Access Report

9 Gregory Hill Drive, Gledswood
Gledswood Hills High School

Prepared for: Department of Education (DoE)
Our Ref: 24000384 | Issue date: 25 March 2025

Figure 3. Access via Principal Pedestrian Entrance

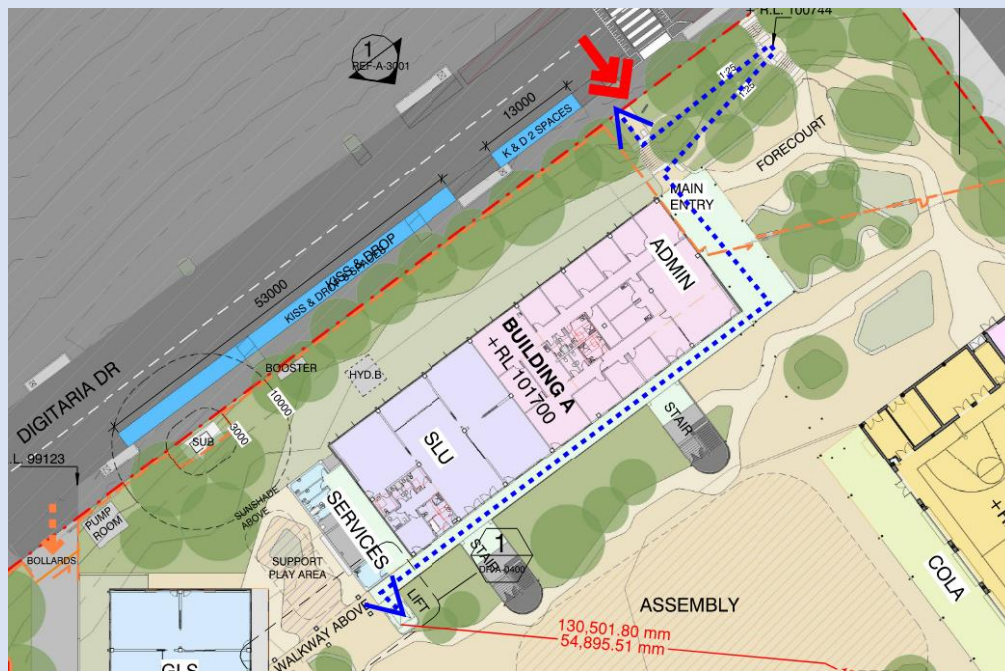
Compliance Comments
<p>Principal Pedestrian Entrance (PPE) linkage via Digitaria Drive:</p> <ul style="list-style-type: none"> ○ Access is achieved from the allotment boundary via compliant (1:25) walkway in accordance with AS1428.1 and DDA Premises Standards. ○ Stairs at allotment boundary provide set back of 900mm minimum as prescribed under AS1428.1. <p>It is noted that there is a distance of over 50m from the proposed lift to the furthest stairwell, raising an equity-of-travel-distance issue. The nominated location of the lift is based on the following rationale:</p> <ul style="list-style-type: none"> ○ The lift is positioned in the building closest (facing Digitaria Drive) to the Principal Pedestrian Entrance (PPE) for staff, students, and visitors. ○ It is located adjacent to the Support Learning Unit home base on the ground floor of Building A. ○ All buildings are linked via outdoor covered walkways that provide on-grade, weatherproof access to all levels and potential areas for respite along the paths of travel. ○ The stairs located more than 50m from the lift are in Building C, situated closest to the secondary entry of GHHS. ○ Accessible car parking bays have a direct line of sight to the lift's location.

Figure 4. Access via Secondary Pedestrian Entrance

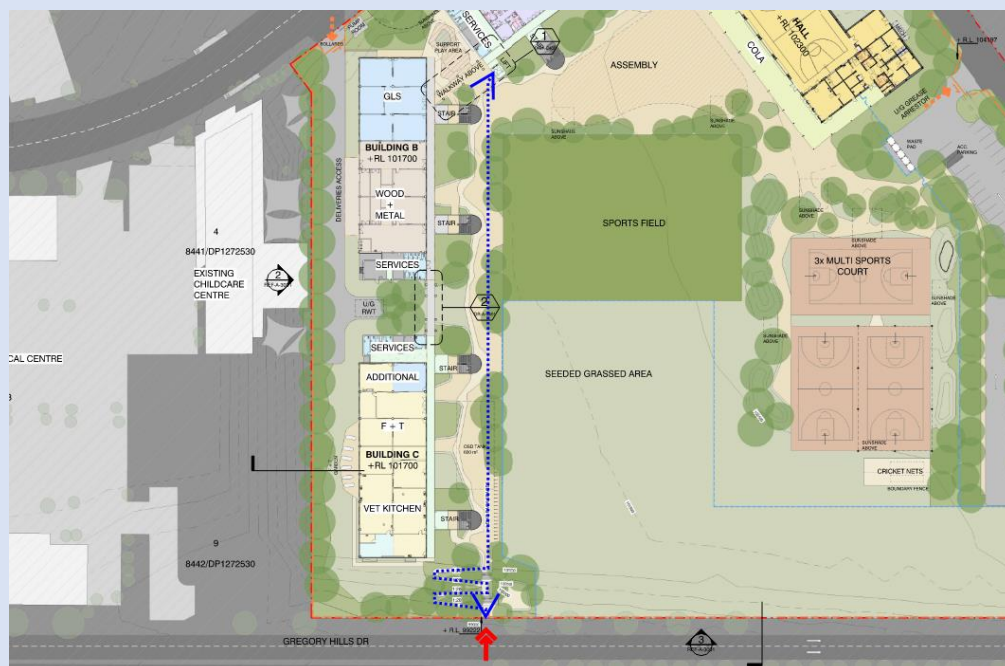
Secondary Entrance Linkage via Gregory Hills Drive:

- Access is achieved from the allotment boundary via series of compliant (1:20) walkways in accordance with AS1428.1 and DDA Premises Standards. This is under 3.6m height.
- Stairs at allotment boundary provide set back of 900mm minimum as prescribed under AS1428.1.

Figure 5. Access from the Access car parking bays to Lift Access

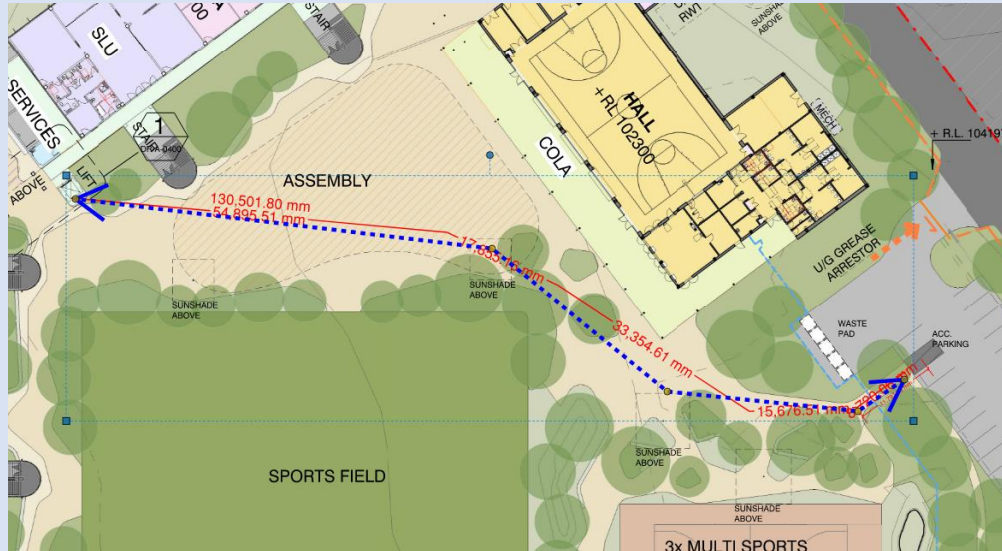
Linkage to Accessible Carparking Bay:

- Access is achieved from the accessible car parking bays (x2) to passenger lift via assembly area in accordance with AS1428.1 and DDA Premises Standards.
